The Commission has issued the enclosed Amendment Nos. 69, 65 and 41 to Facility License Nos. DPR-33, DPR-52 and DPR-68, respectively, for the Browns Ferry Nuclear Plant, Units Nos. 1, 2 and 3. These amendments consist of changes to the Appendix B Environmental Technical Specifications in response to your request dated August 29, 1979 (TVA BFNP TS 130).

BROWNS FERRY NUCLEAR PLANT, UNIT NO. 2

AMENDMENT TO FACILITY OPERATING LICENSE

Amendment No. 65
License No. DPR-52

BROWNS FERRY NUCLEAR PLANT
TVA Office of Power
Organization for Operation
of Nuclear Plants
Figure 5.2-1

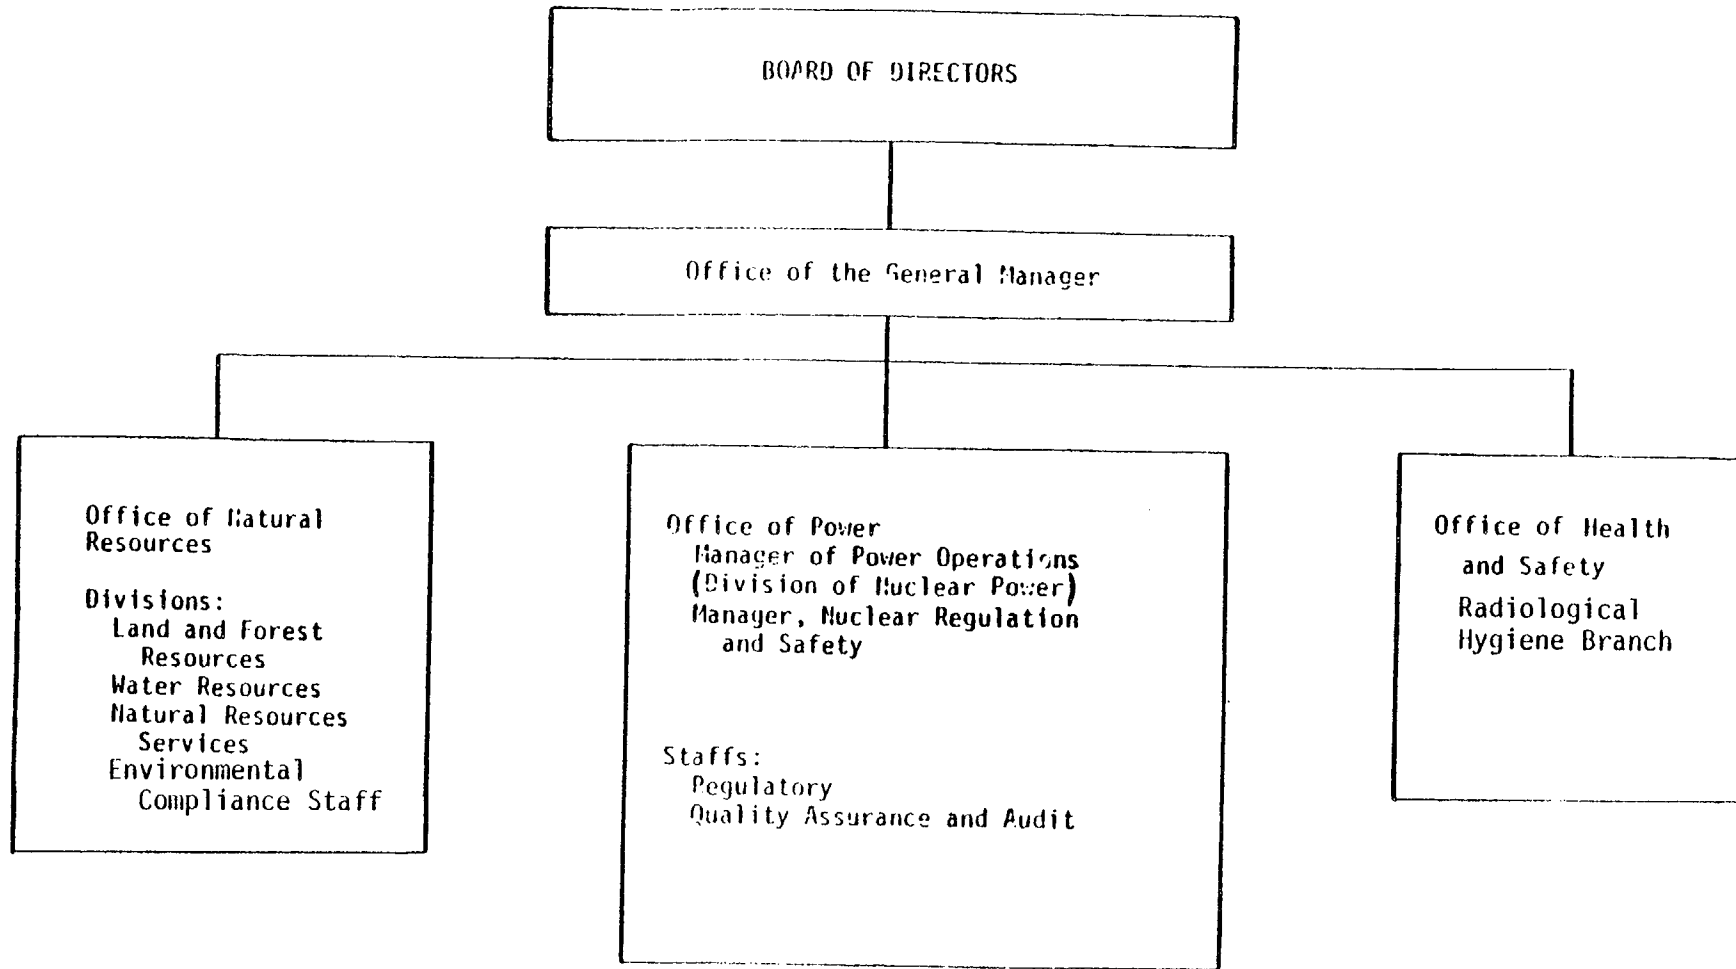
These amendments revise the Environmental Technical Specifications to: (1) delete section 2.1 which presently specifies limiting conditions of operation (LCO) on thermal discharge limits, (2) delete section 2.2 which specifies LCOs for chemical discharges to the aquatic environment, (3) delete section 3.1.2 which describes the expected maximum concentrations of chemicals of the plant effluents before and after mixing in the river, (4) delete Section 5.4 which specifies actions to be taken if a water quality LCO is exceeded, (5) delete section 5.6.3.b which specifies reporting requirements when an LCO on water quality is exceeded, (6) delete item 5.7.1.C which specifies the records and logs to be maintained on LCO violations of water quality and (7) change the titles in section 5.0 (Administrative Controls) of the offices within TVA responsible for environmental activities.

Administrative Controls to change the titles and organizational elements within TVA responsible for environmental activities is being made to reflect recent organizational changes within TVA.
